D/DRC Case

1721 Gadsden Street

DESIGN/DEVELOPMENT REVIEW COMMISSION
DESIGN REVIEW DISTRICT
HISTORIC AGENDA
EVALUATION SHEET
Case # 10

NATURE OF REQUEST: Request Certificate of Design Approval for exterior changes and Preliminary Certification for the Bailey Bill

1 Proposed Front Elevation
A-2.01 1/4" = 1'-0"

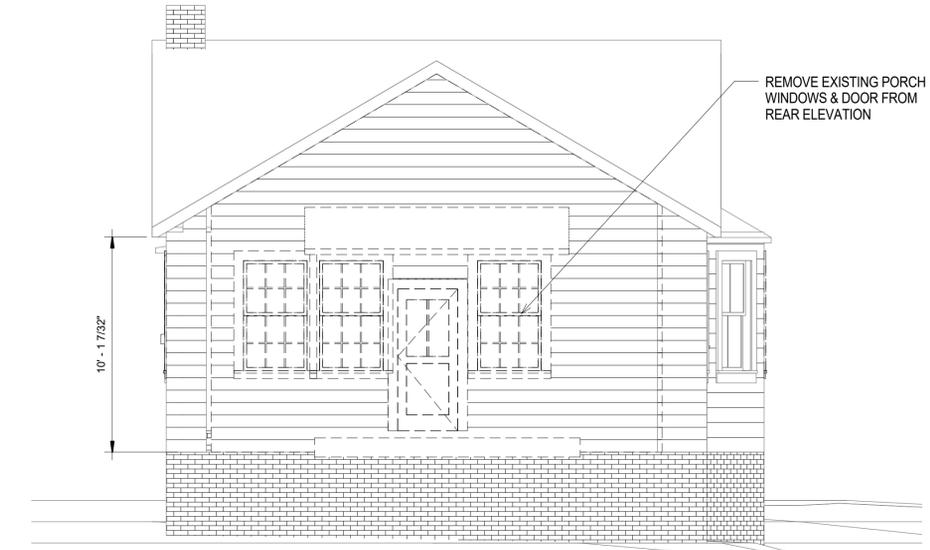
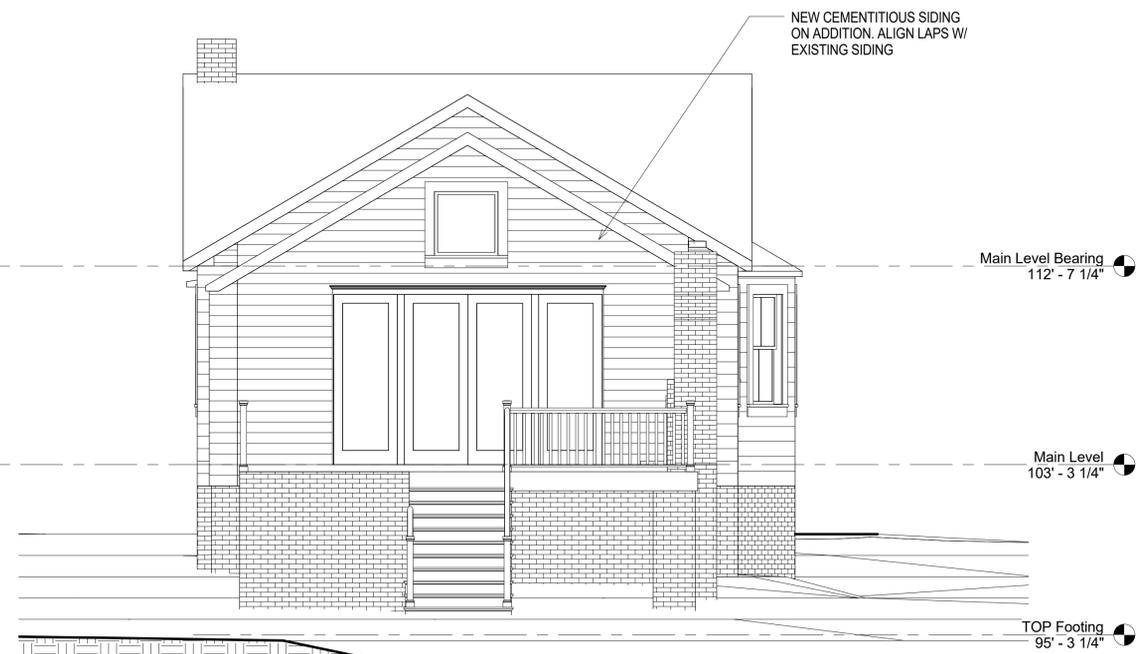
The façade that has been removed was potentially a symmetrical façade with a central door flanked by two single windows, since there is a central front gable intersecting the roof. This roof form is often seen on a Folk Victorian design with a central door. The original front wall has been heavily altered and leaves little information to inform about the door placement.

What is proposed are two sets of paired windows flanking the central door. Unfortunately, they appear overly large individually in comparison to the original windows in the building, and are disproportionate to the façade and rhythm of openings on the side elevations when paired together. There are no other paired windows on the building. Other small historic homes similar to this in the area either had single windows or two single windows separated by wall space. Using the age and architectural cues from this building it would seem that the façade should have single windows symmetrically flanking a central door. Paired windows appear to be somewhat conjectural.

As mentioned earlier, there is no documentary evidence as to the original façade, which must be completely rebuilt, but its existing style and placement of openings and features suggests a central door flanked by two single windows. The doorway likely had other enhancements popular in the late 1800s, such as sidelights or a transom, or both. Staff recommends reducing the proposed paired windows to single windows, and could work with the applicant on any additional window treatment around the door.

- That the proposed paired windows on the façade be reduced to single windows, compatible in size with the historic windows on the building
- That any additional transom or sidelight detail for the front door be worked out with staff
- That the foundation not gain any paint or parge coat on non-coated brick, but that the foundation under the non-original bay may be painted or veneered as it has already been painted
- That the new porch columns be reduced to an 8 inch width maximum, but could be 6 inches
- That any original windows be repaired, but if beyond repair as determined by staff, that they be replaced in kind with wood windows matching the profiles of the original
- That if any historic details are discovered during demolition affecting the proposed façade or porch arrangement, alterations to the design can be worked out with staff
- All details be deferred to staff

1 Proposed Right Elevation
 A-2.02 1/4" = 1'-0"

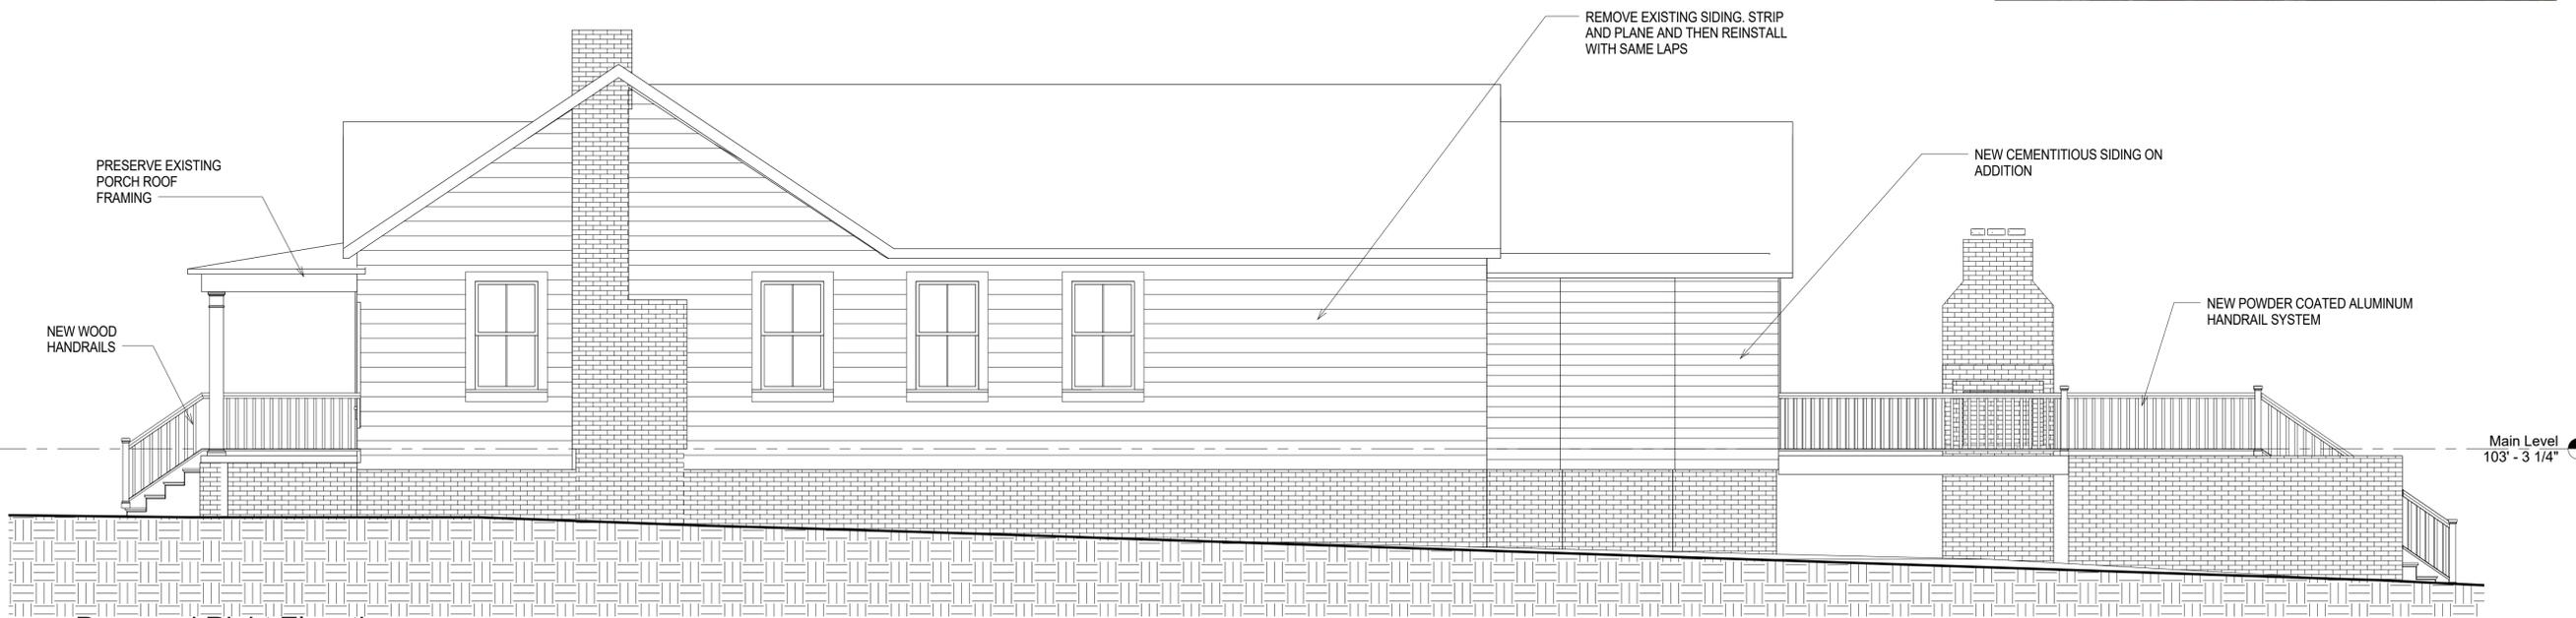
The treatment for the wood siding as proposed is to remove all of the siding, strip the paint and plane where necessary to smooth out imperfections and then re-install the siding. This is a fairly aggressive process that has the potential to damage siding during removal so the

utmost care should be taken. Stripping may sufficient without the added step of planing. Fortunately the oldest siding on the front half of the building is exceptionally thick so it may handle the removal better than thinner wood siding. Given the massive paint failure occurring on the oldest siding it will require a great deal of effort to get back to a wood surface, but removal efforts should not damage the original siding. For the “newer” siding on the rear addition of the building, which may not have as extensive of paint failure, scraping and sanding in place may produce favorable results.

1 Proposed Left Elevation
A-2.03 1/4" = 1'-0"

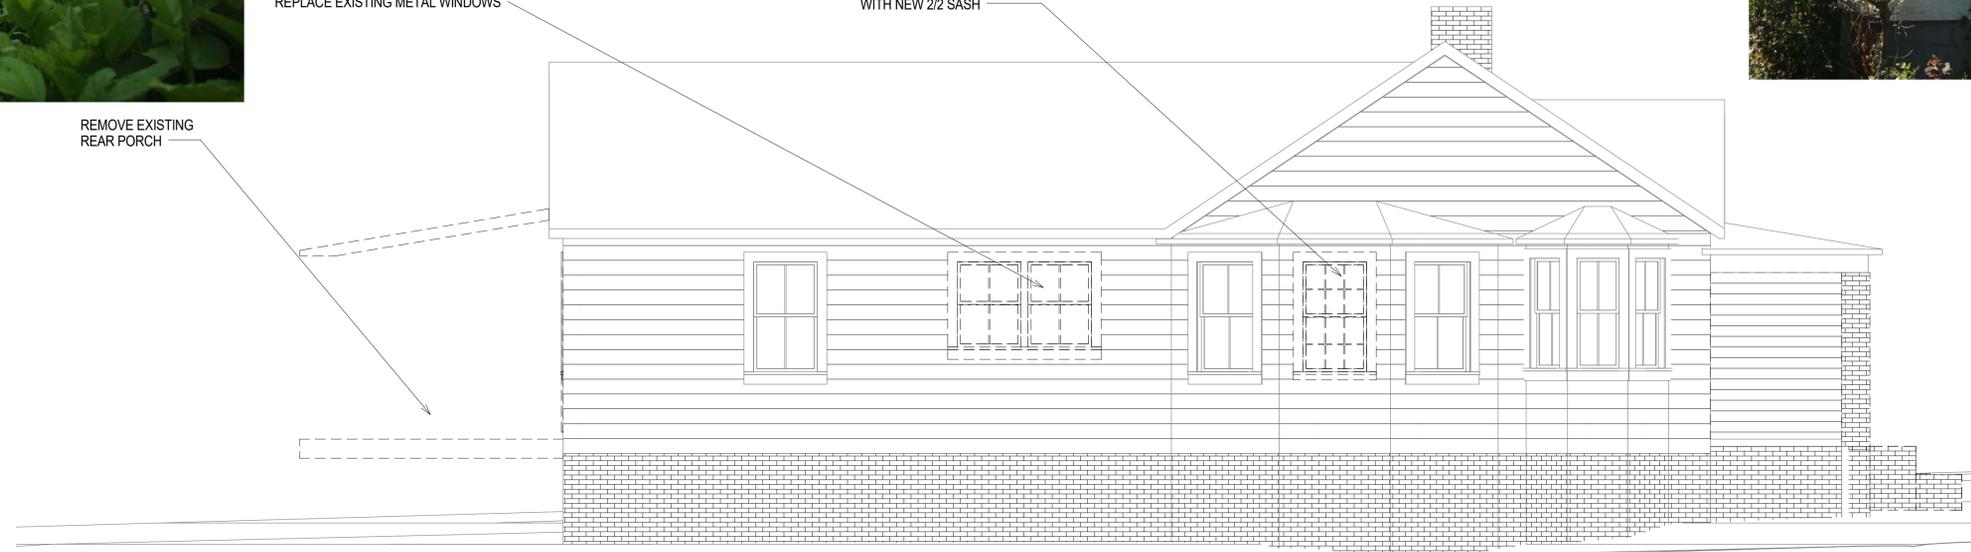
The only item that is proposed that suggests “removal” of a historic characteristic of the property is a note on the architectural plans to repair a part of the brick foundation and then to “paint or parge.” The unpainted brick foundation that is visible on the front and sides should remain as brick and not be covered with a mortar or stucco system, nor should it gain a coat of paint as that would not retain and preserve a historic feature. For the foundation under the front bay, which appears to be either parged or to have concrete block, brick veneer or paint added to this feature may help it to blend in to the rest of the building, but would also leave the original foundation intact.

The windows have some deterioration in a number of locations, but most commonly along the bottom rail. These rails will likely need to be repaired or replaced on several sashes in order for them to be restored to working condition. Some missing, replaced, or severely deteriorated windows, after review by staff, could be replaced by wood windows to match the original configuration. Some replacement of non-original windows is indicated in the architect's renderings, and indicates at least one opening being opened back up to its original large size. Staff has also reviewed most of the windows and recommendations are included at the end of the evaluation. For the front bay, for instance, which has a shorter top sash than the bottom sash, only 3 of the 6 sashes found here appear to be historic, and they are in disrepair. For the front and side window, the only ones visible, the best of the sashes can be used or, if severely deteriorated, replaced with windows of the same unusual configuration, as this is part of the evidence that the bay was an addition.

- That the foundation not gain any paint or parge coat on non-coated brick, but that the foundation under the non-original bay may be painted or veneered as it has already been painted
